# 36 WELLINGTON ST

COLLINGWOOD

TOWN PLANNING

#### Attachment 3 - Head, Department of Transport Referral Comments

TP 9-101

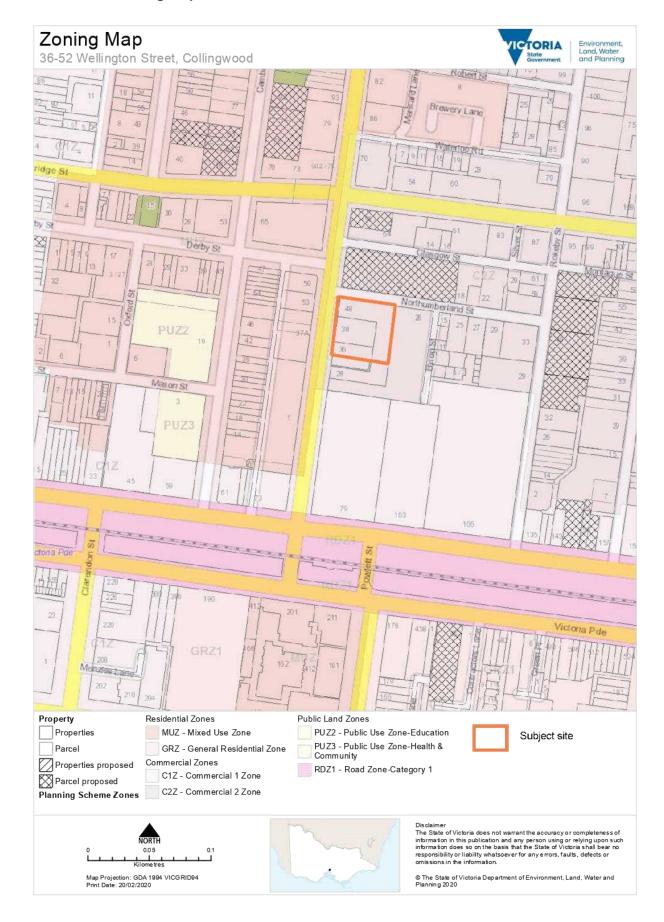
- The proposed use of brick paving in the public realm / road is not supported.
- Urban design and Open Space do support the principle of a better public realm outcome
  and a more cohesive space achieved through a better quality material. The use of
  bluestone pavers as per the City of Melbourne standards for pedestrian and vehicular
  standards could be applied. This is subject to resolving an outcome that satisfies the
  engineering requirements such as the camber on the road, the kerb profile and drainage.
- A delineation of the title boundary will need to be made through a high quality public realm material such as a metal banding.
